SOUTH WEST MILTON KEYNES

Stage 1 Road Safety Audit and Designer's Response (Junctions in Milton Keynes)

MKC MITIGATION DESIGNS

Stage 1 Road Safety Audit

Google image 1 (May 2012)— Access into recycling centre and bottle dump stables

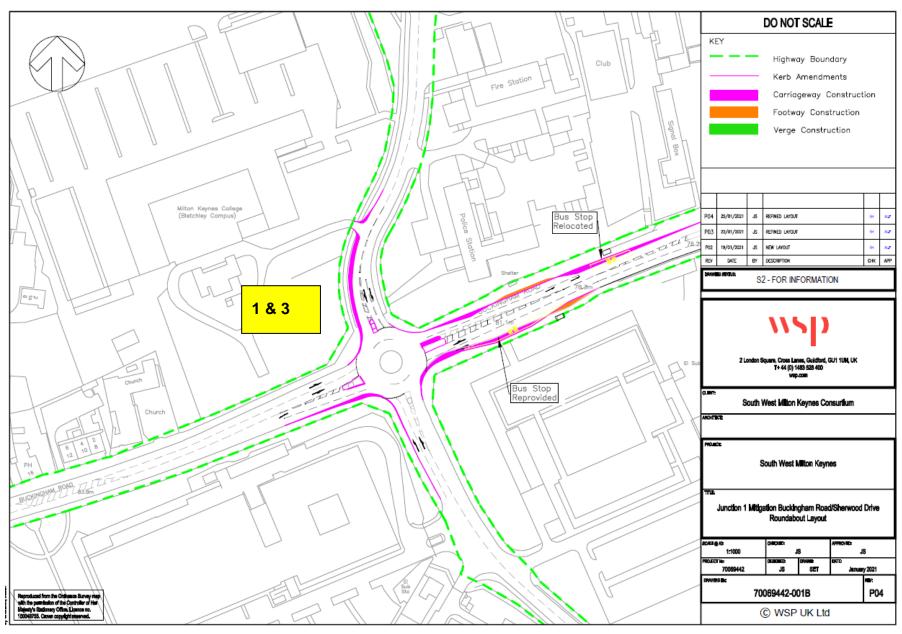
The audit team are concerned of the proposed location of the pedestrian/cycle and equestrian route tie-in on Buckingham Road outside the recycling centre. The proposed design makes WCHR's join Buckingham Road at the entrance into the recycling centre depot and within the vicinity of the entrance off Whaddon Road. There is a risk that WCHR users joining Buckingham Road at this location could come into conflict with passing or turning vehicles, potentially leading to serious/fatal injury.

This risk is increased due to regular LGV/HGV movements in the immediate area.

It is recommended that good visibility splays, removal of vegetation, signing and enhanced visual features are proposed at this tie-in, warning vehicle users to expect WCHR activity.

2.9.1. Noted. Vegetation will be trimmed to ensure good visibility for WCHRs in this location and advance signage and markings will be used to ensure drivers using the recycling centre access are warned of the equestrian route. The specification and location of the features will be provided at the detailed design stage, which will be subject to a Stage 2 RSA.

Google image 2 (May 2012) – Approx. location of Pegasus crossing

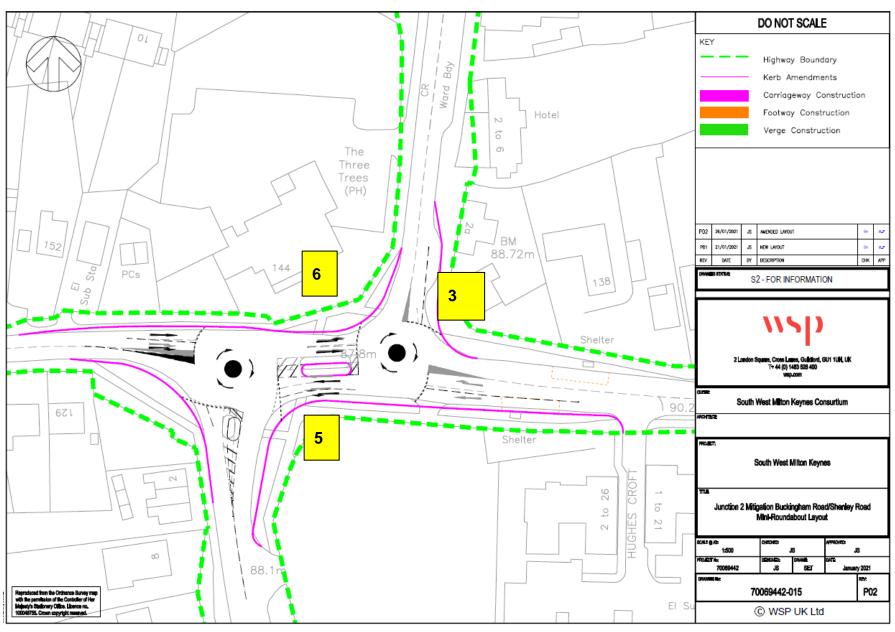
From the drawings and online mapping, the audit team place the proposed Pegasus crossing in the vicinity of the red arrow on google image 3. The location is behind a mass of vegetation on the nearside and in vicinity of the tree on the offside looking to the southeast.

The vegetation will need to be completely removed in order to afford visibility to the Pegasus crossing on both sides of the carriageway to reduce the likelihood of collisions involving WCHR and motor vehicles.

It is recommended that all vegetation in the visibility splay of the Pegasus crossing is removed to allow adequate visibility to the crossing at all times of the year.

2.11.1. Noted. Vegetation will be cut back in this location. Routine maintenance of the vegetation to ensure visibility is not restricted will be the responsibility of Buckinghamshire Council (BC) as local highway authority for Whaddon Road.
